SUBJECT: BEAVER VALLEY UNIT 2 ISSUANCE OF AMENDMENT (TAC NO. 73605)

Amendment No. 20  
License No. NPF-73

ATTACHMENT TO LICENSE AMENDMENT NO. 20

SAFETY EVALUATION BY THE OFFICE OF NUCLEAR REACTOR REGULATION  
RELATED TO AMENDMENT NO. 20 TO FACILITY OPERATING LICENSE NO. NPF-73

**FIGURE 3.6-1**  
**MAXIMUM ALLOWABLE PRIMARY CONTAINMENT AIR PRESSURE**  
**VERSUS SERVICE WATER TEMPERATURE**

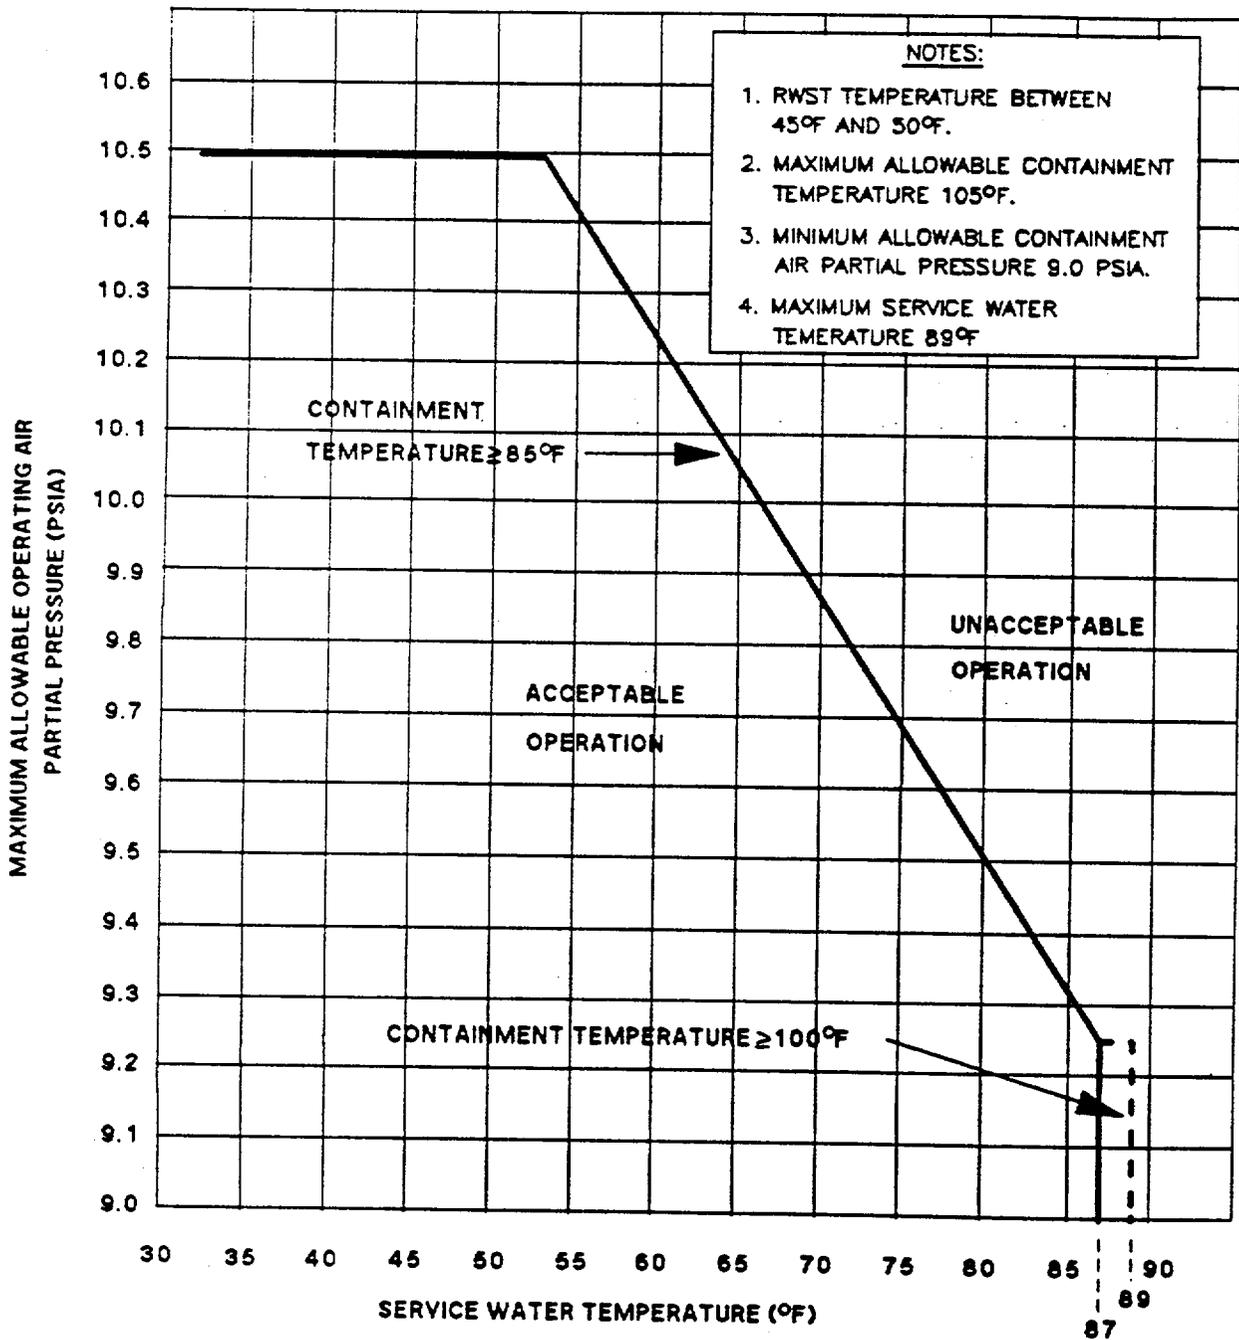
Figure 3.6-1, the maximum allowable Primary Containment Air Pressure versus river water temperature curve, has been revised to reflect the revised containment depressurization analysis based on an RWST temperature limit and the increased river water temperature limit. The revised figure includes additional containment average air temperature restrictions when operating with

river water temperature above 87°F as required to support the assumptions of the revised analysis. Technical Specification 3.6.1.4 and 3.6.1.5 for containment maximum air partial pressure and containment minimum temperature are revised to be consistent with the new Figure 3.6-1.

- a. Use of a maximum RWST temperature (50°F)
- b. Containment quench spray thermal efficiency is assumed to be 99% (95% was assumed in the licensing basis), and recirculating spray thermal efficiency is assumed to range between 99% and 95% (a constant 90% was assumed in the licensing basis). These are currently acceptable values.
- c. Service water flow through the recirculation spray heat exchangers was reduced from 12000 gpm to 11000 gpm.

The results of the licensee's analyses show that the Containment Depressurization System is capable of reducing the containment pressure to subatmospheric within 1 hour for river water temperature up to 87°F. Depressurization will still be attained in an hour if river water temperature is at 89°F or less and initial containment temperature at greater than 100°F. Thus no revisions need be made to accident evaluations in the unit's licensing basis. Furthermore, the reanalysis showed that NPSH requirements will continue to be satisfied for the low head safety injection pumps and recirculation spray pumps.

3.6.1.4 Primary Containment internal air partial pressure shall be maintained  $\geq 9.0$  psia and within the acceptable operation range (below and to the left of the applicable containment temperature limit line) shown on Figure 3.6-1 as a function of service water temperature.

- a. Greater than or equal to 85°F and less than or equal to 105°F  
or
- b. Greater than or equal to 100°F and less than or equal to 105°F

- a. A minimum water level at or above elevation 654 Mean Sea Level, at the intake structure, and
- b. An average water temperature of  $\leq 89^{\circ}\text{F}$ .
